Ref: TR010063

**Application by Gloucestershire County Council (the Applicant) for an Order Granting Development Consent for the M5 Junction 10 Highways Improvements Scheme**

**Submission from National Highways for Examination Deadline 4 (3 September 2024)**

Figure 1 – Extract from Saturn validation report prepared by the Applicant [Figure 10 extracted from Technical note]

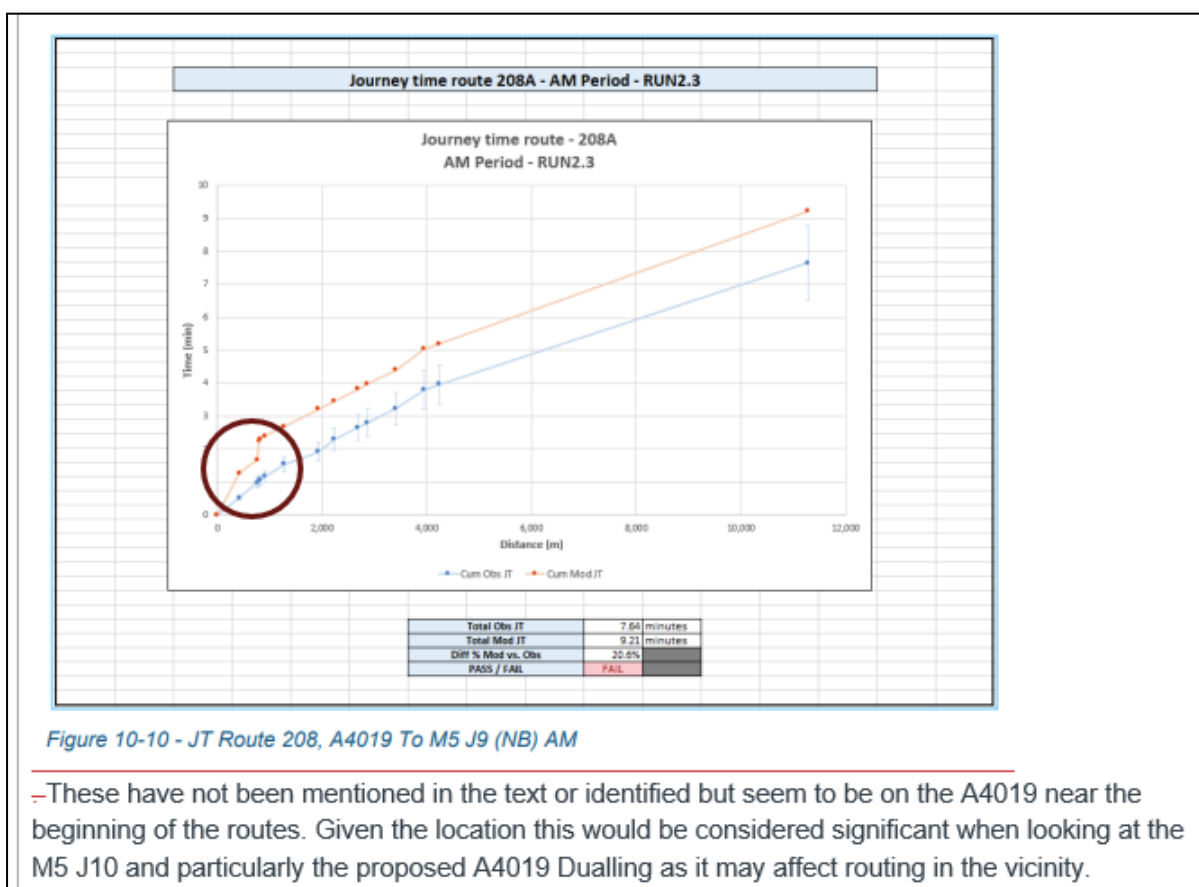
The graph, shown below in Figure 1, having been extracted from the validation information provided with the SATURN model by the Applicant, demonstrates where the significant difference is between the observed journey times and the modelled journey times. The guidance in paragraph 4.3.4 is specifically referring to exactly this situation where the difference in journey time over the whole route occurs at a

localised level; in this case in about the first 10% of the journey. Resolving the issue at this segment of the journey would bring the whole route back within the appropriate 15% margin for validation.

The other point that becomes very clear from this graph is that the only reason the journey time variance is only marginally in excess of 15% is because of the length of the route. Considering just the journey time along the A4019, a distance of around 4km would result in a far greater variance and highlight the issue to a much greater degree. The severity of the issue is significantly masked by the reliable journey time along the M5.

– These have not been mentioned in the text or identified but seem to be on the A4019 near the beginning of the routes. Given the location this would be considered significant when looking at the M5 J10 and particularly the proposed A4019 Dualling as it may affect routing in the vicinity.

Figure 3 - Kingsditch roundabout [extracted from technical note]

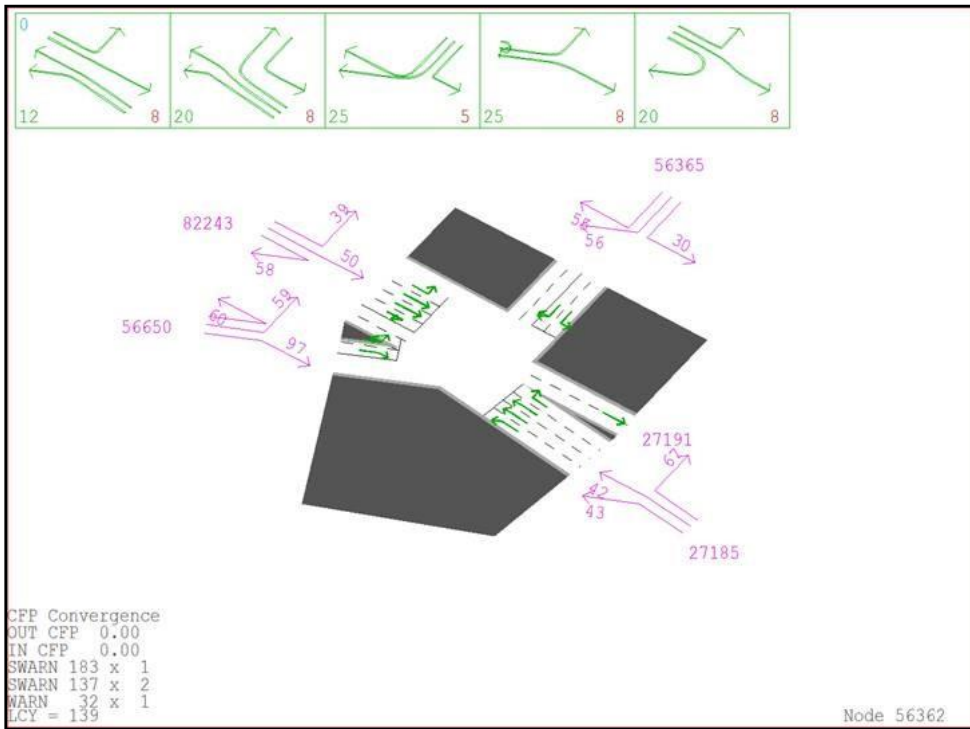
The junction layouts as represented in the Saturn model are shown below in Figure 3 and 4:

These two junctions require recalibration and revalidation in the base model for all three time periods (AM peak, interpeak and PM peak). While we cannot confirm what the changes to the signal timings should be, we can provide the initial advice that the intergreen times could be a focus of any sensitivity analysis undertaken by the Applicant. This is because the intergreen times are all set at 10 seconds in the model, and it is unlikely that this is correct across the whole junction. The intergreen settings should be taken from the controller settings for each junction to make the model reflective of the current road operation.

It is appreciated that the junction was operating under MOVA control which will vary the length of green time across the modelled time periods in response to the traffic demands for each movement. However, it will be possible to identify an appropriate set of timings from the controller logs to act as a suitable start point and this can be finessed through model runs to identify a set of timings that provide the best fit to the junction delay as experienced in the base year. It may also be appropriate to adjust some of the stop line saturation flows if these are lower than were being achieved.

In order for National Highways to be able to accept the SATURN model as being fit for purpose, and in line with National Highways requirements, the two journey time for routes, 208 and 209 in the northbound direction both need to meet the validation criteria required by TAG Unit 3.1 overall but specifically when considering only the section from the start of the route as far as the M5 Junction 10 as this represents the most critical section of the journey.
